**Addendum to the Groundwater Flow Model
for the Central Carbonate-Rock Province:
Clark, Lincoln, and White Pine Counties
Groundwater Development Project**

DRAFT

August 2010

Figure 2-1
Location of Hydraulic Head Observations in Model Area

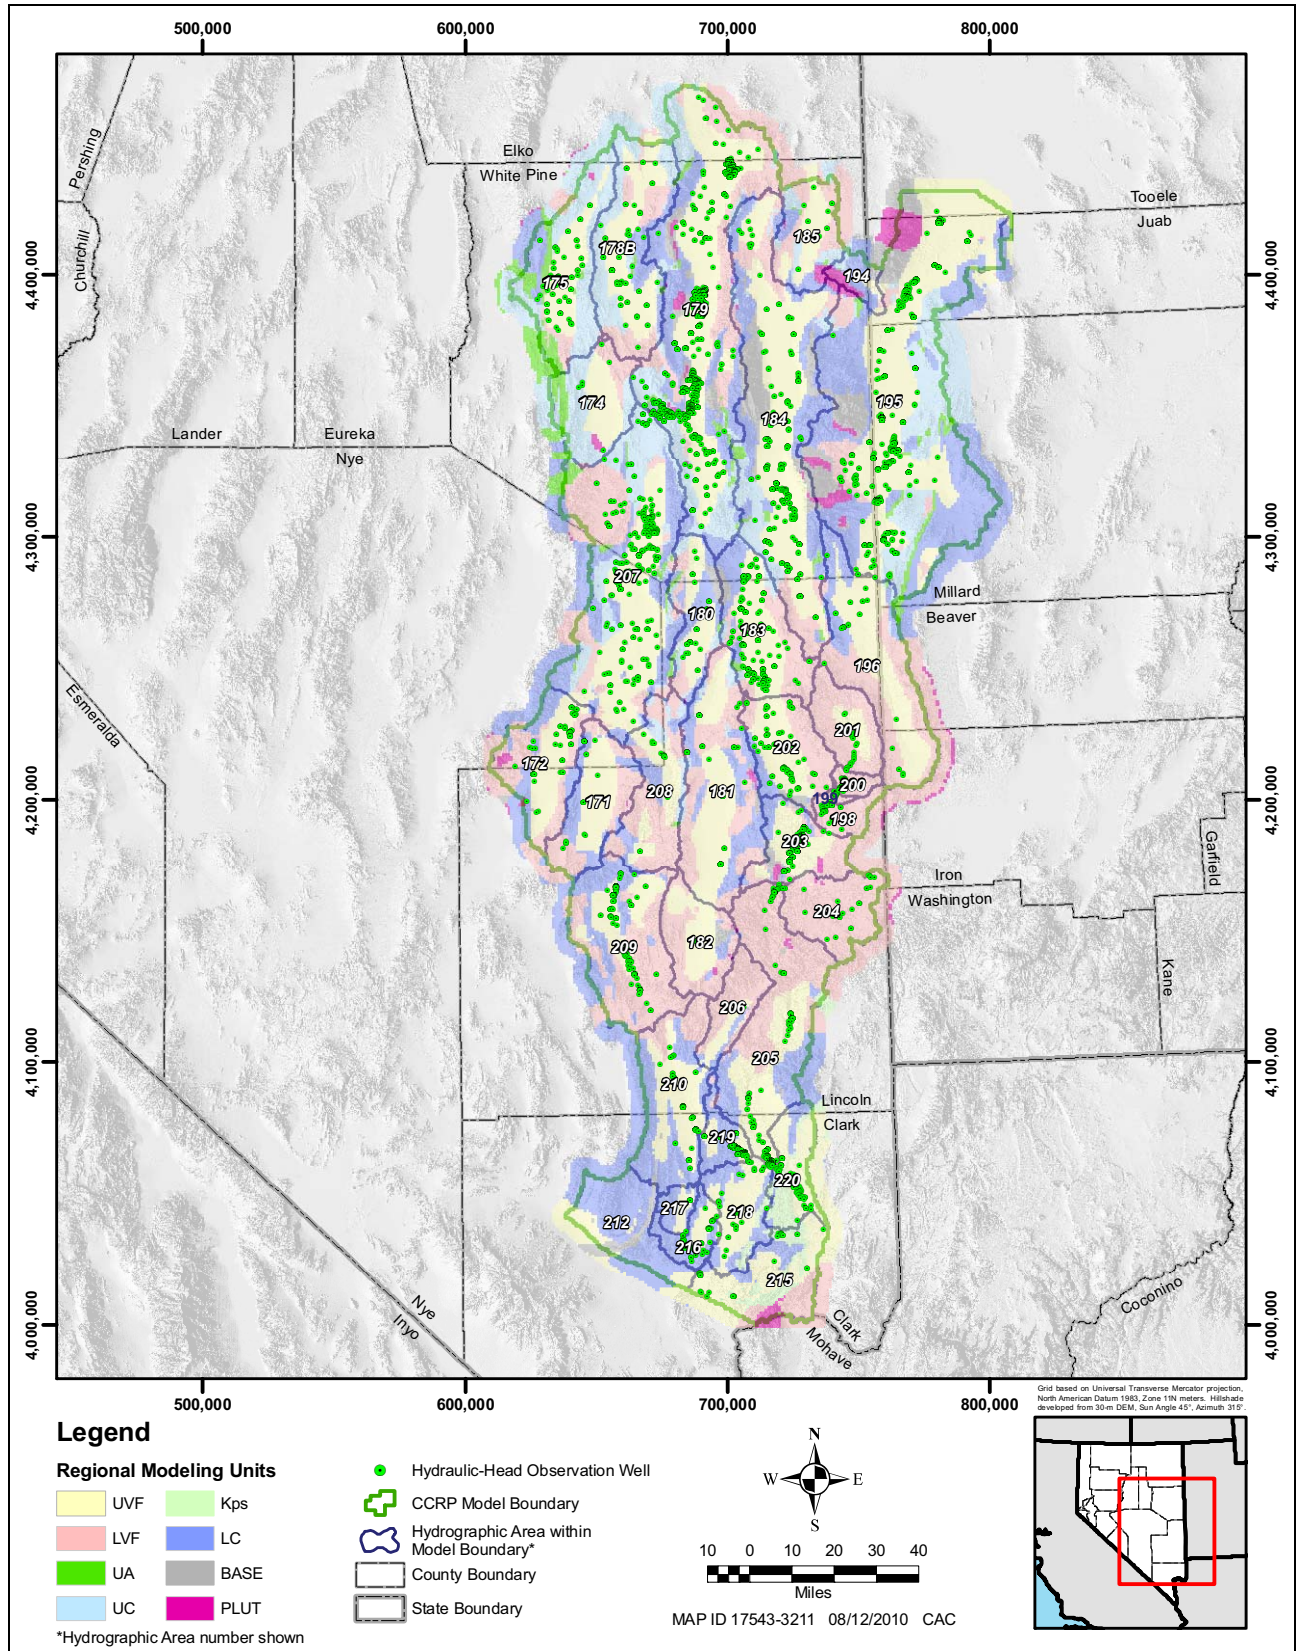
Figure 4-40 on page 4-83 of the numerical model report shows the spatial distribution of hydraulic-head observation wells by aquifer-material type from an earlier iteration of the numerical model report. Figure 2-1 is an updated version of that figure and shows the locations of head observations used in the transient numerical model (both original and modified versions). In addition, Figure 2-2 is provided in this addendum to show the locations of drawdown observations. The hydraulic head and drawdown observations are provided in electronic format (see DVD).

Figure 3-1 Location of Southern Snake Range HFB Relative to Big Springs in Original (A) and Modified (B) Models

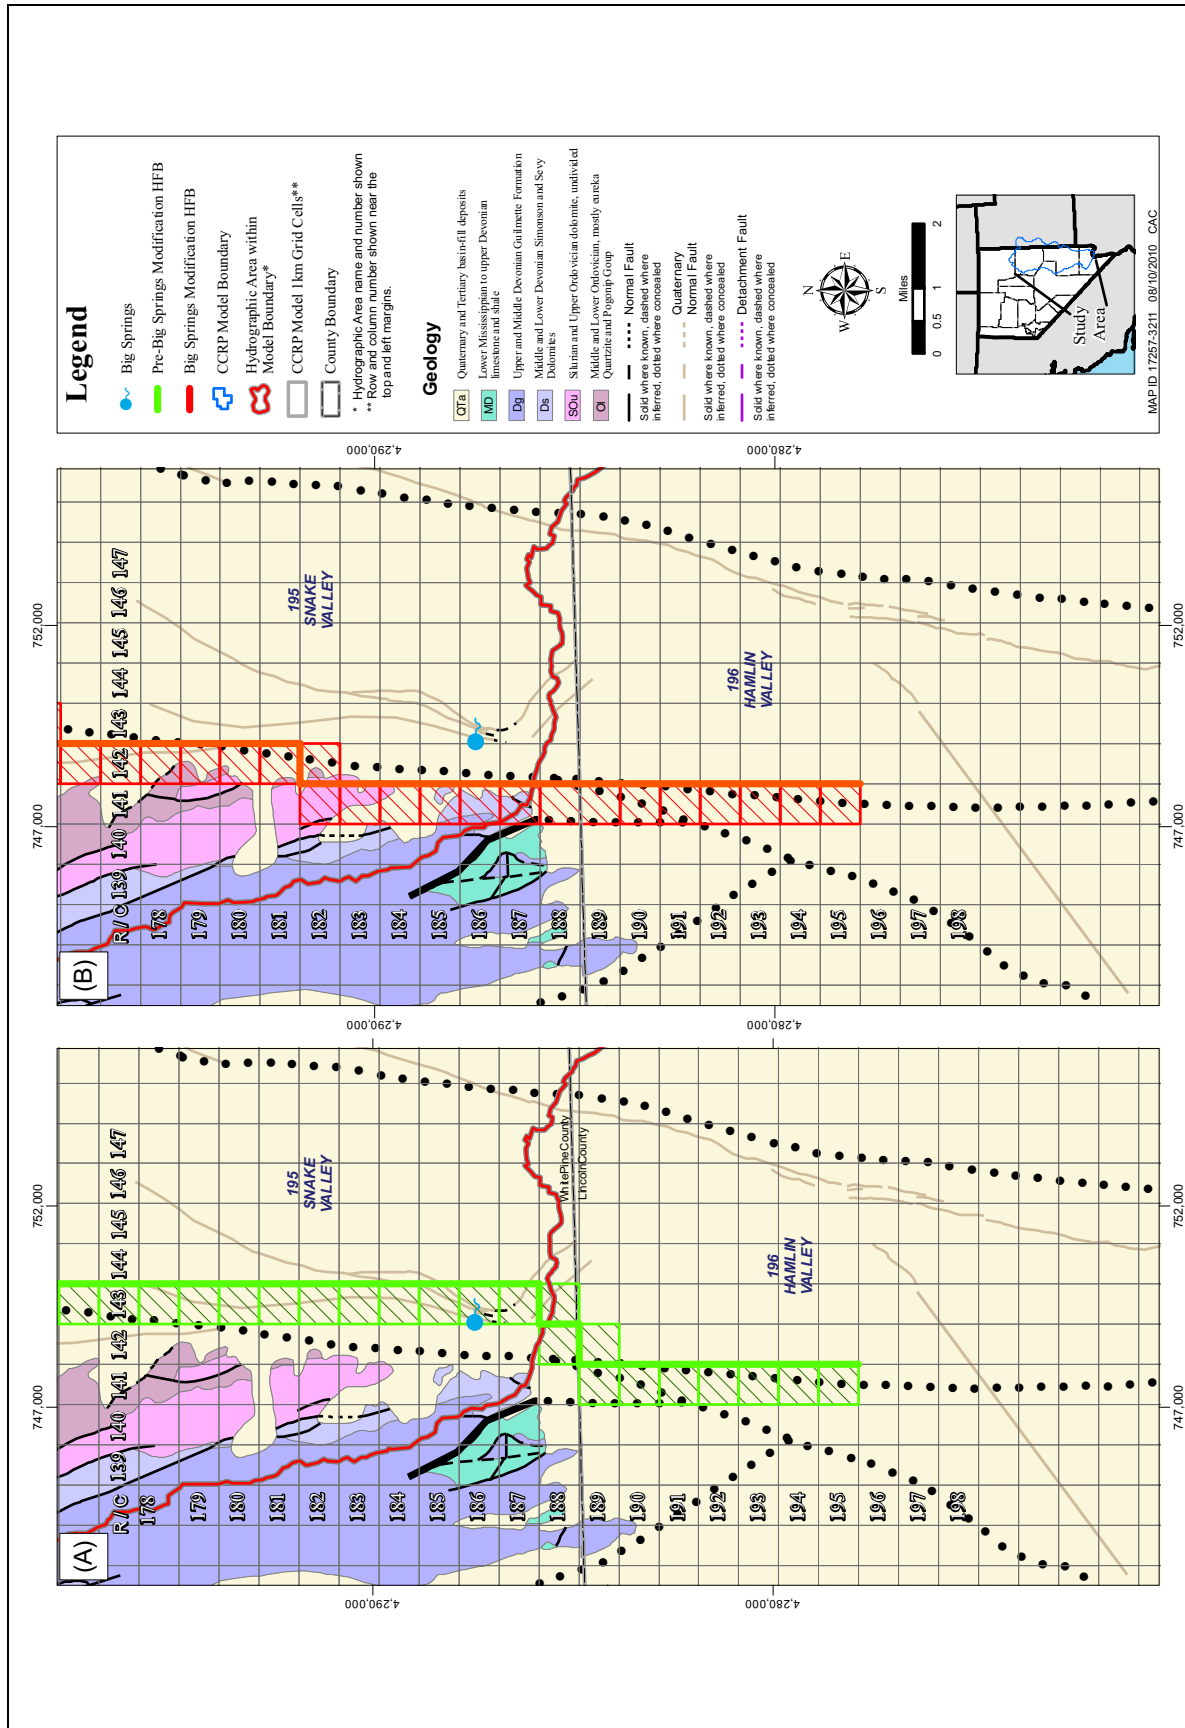
The representation of the faults present in the Big Springs area in Snake Valley was changed in the modified numerical model as shown in [Figure 3-1](#).

The southern Snake Range HFB was previously designed to represent a combination of the range front fault located in that area and the smaller Quaternary faults located downgradient of Big Springs and other smaller springs not simulated in the numerical model. The HFB followed the range front fault located along the length of the southern Snake Range over most of its length. In the area where the Quaternary faults occur, the HFB approximately followed their strikes (Map A in [Figure 3-1](#)). This representation was made because: Quaternary faults which correspond to well-defined changes in texture, and therefore, drastic changes in hydraulic properties can be simulated with HFBs and this feature improved the model fit for the flow at Big Springs.

In the modified model, the HFB in the area of Big Springs was moved to the west to match the location of the range front fault (Map B in [Figure 3-1](#)), as requested by the BLM. As a result of this move, the Quaternary faults were no longer represented in the numerical model so further changes were required to simulate groundwater discharge from Big Springs which was represented using the SFR2 package. In order to simulate discharge from Big Springs, input to the SFR2 package was modified as described in the next subsection.

Figure 3-2 Representation of Big Springs in Original (A) and Modified (B) Models (Plan View)

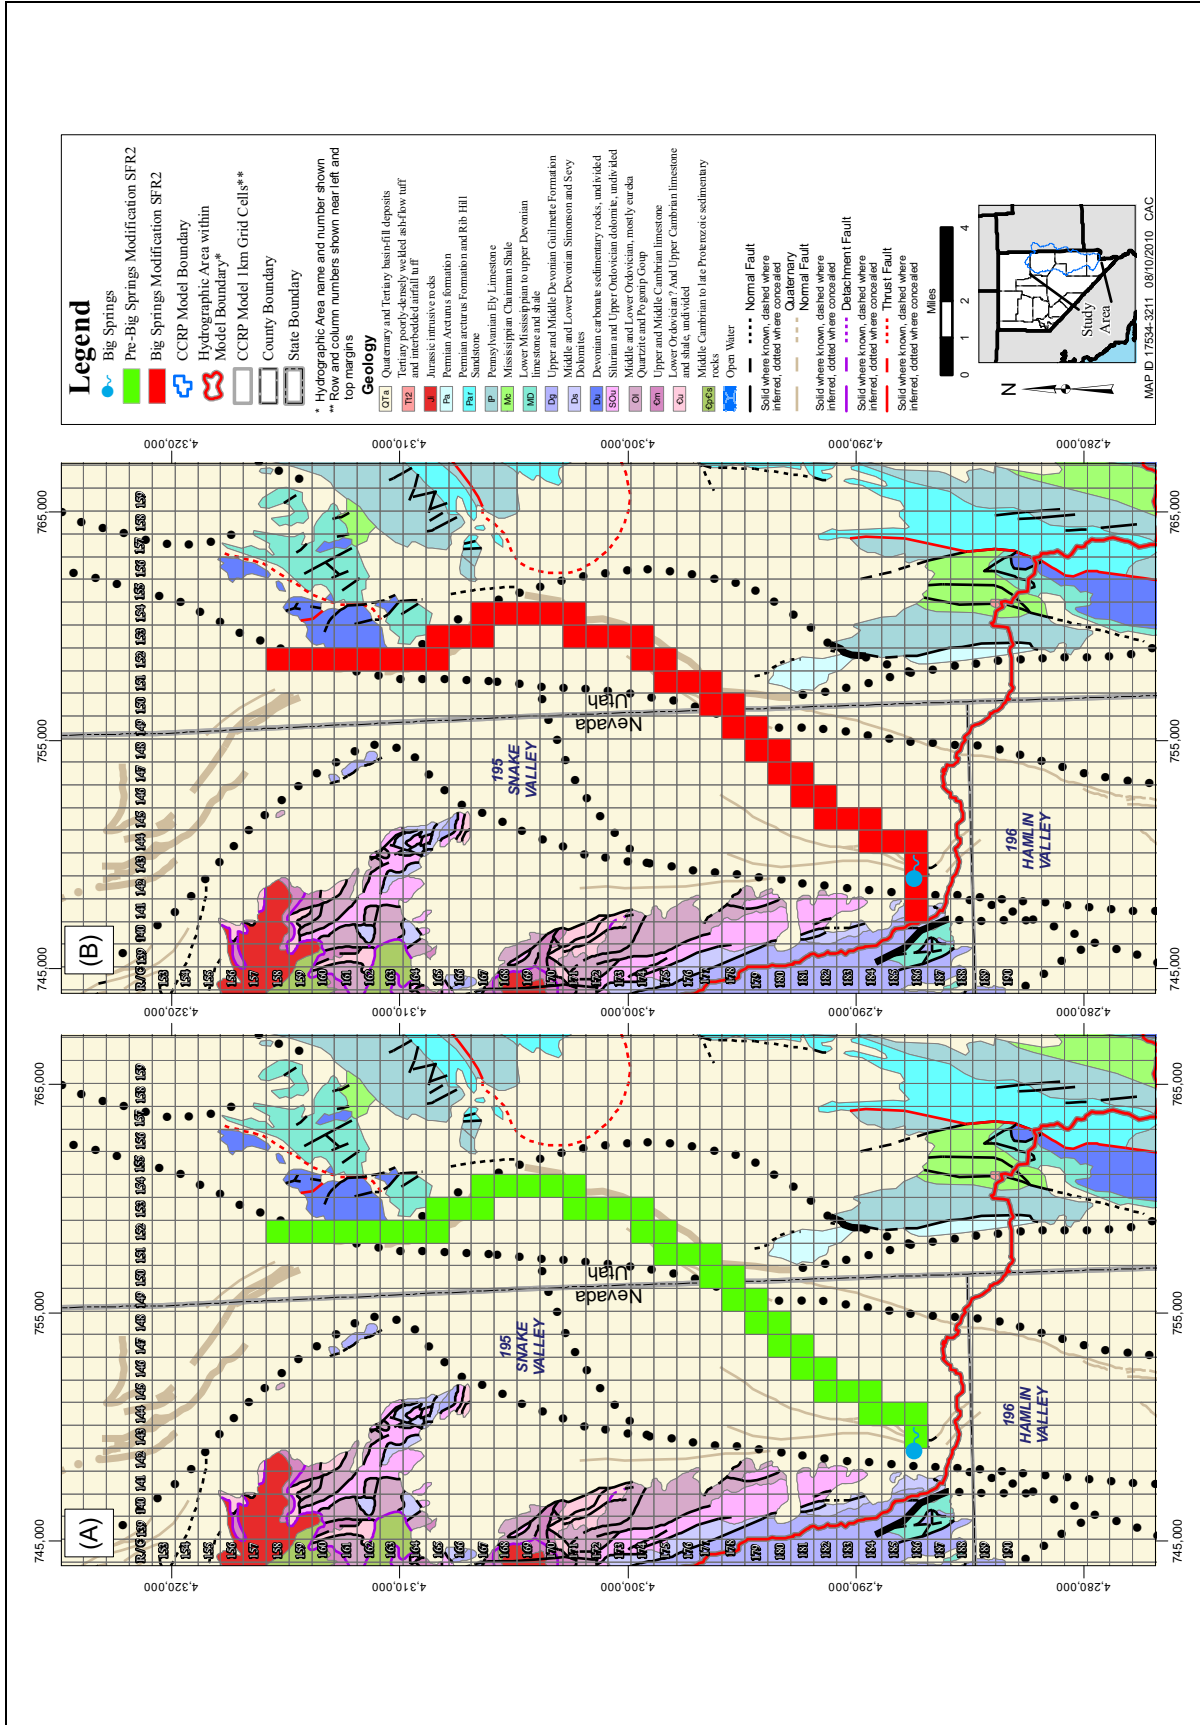
The representation of Big Springs, Big Springs Creek, and Pruess Lake is shown in [Figure 3-2](#) in plan view for the original version of the numerical model (Map A in [Figure 3-2](#)) and the modified model (Map B in [Figure 3-2](#)).

Only the first SFR2 stream segment, representing Big Springs in the original numerical model was modified. In the original version of the numerical model (SNWA, 2009b), Big Springs was only represented by a vertical stream segment at the location of the spring (single cell in Map A in [Figure 3-2](#)). The Big Springs stream segment originated in model layer 7 and extended vertically to layer 2 (top layer in the area). When the HFB was located downgradient of Big Springs (Map B in [Figure 3-1](#)) flow was simulated at the spring.

In the modified model, the Big Springs stream segment was modified to extend across the new location of the HFB in the same model layer (see Map B in [Figure 3-2](#)). The increased head differential across the HFB would force the model to simulate flow from Big Springs. This produced model instabilities so the representation was slightly modified during localized model calibration. The stream segment was deepened to layer 9 upgradient of the HFB.

Figure 3-3
Springs Removed from Numerical Model in Modified Version

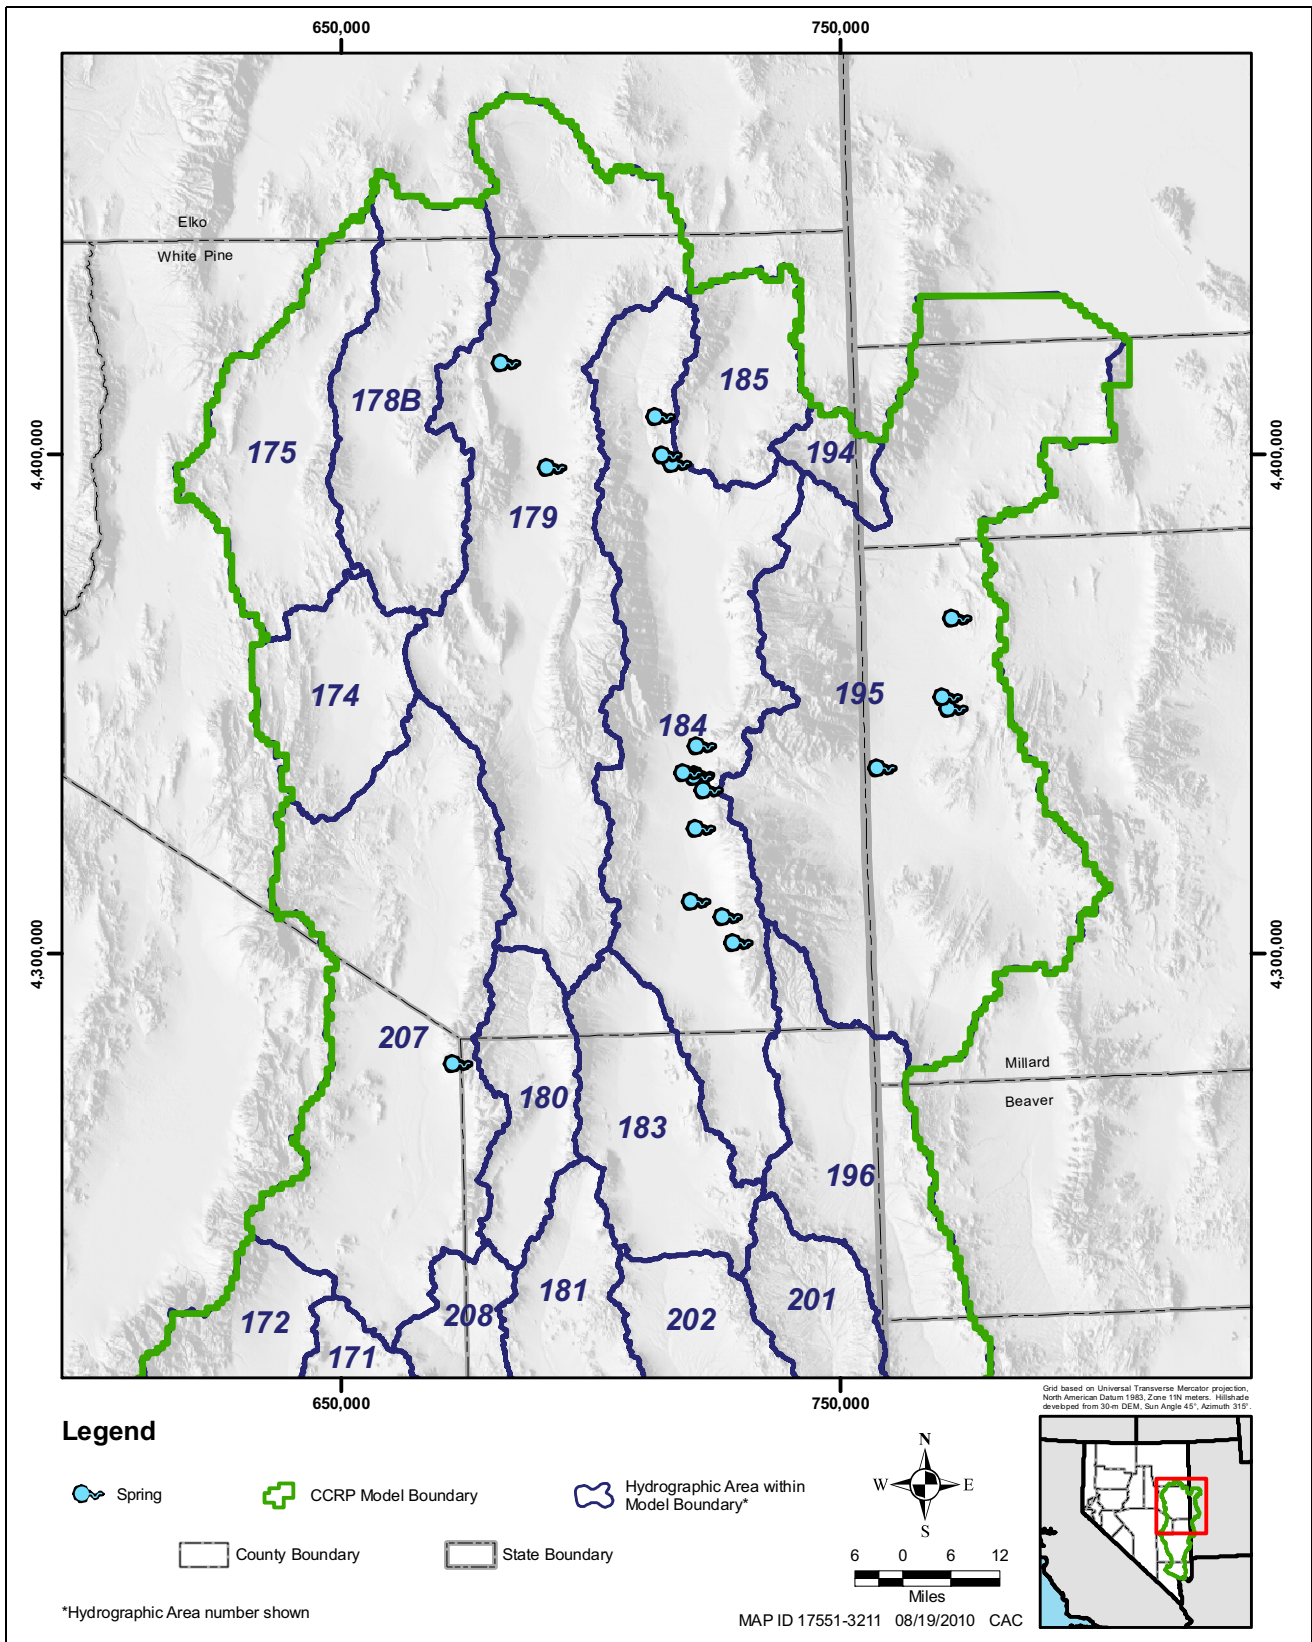
BLM noted that small springs could not be simulated adequately by the regional scale model and requested that those springs be removed from the model. The selected springs were removed from the drain input file and the drain observation file. Nineteen springs were removed from the two files because the regional model is not capable of adequately simulating the flow at these local to intermediate springs ([Table 3-1](#) and [Figure 3-3](#)).
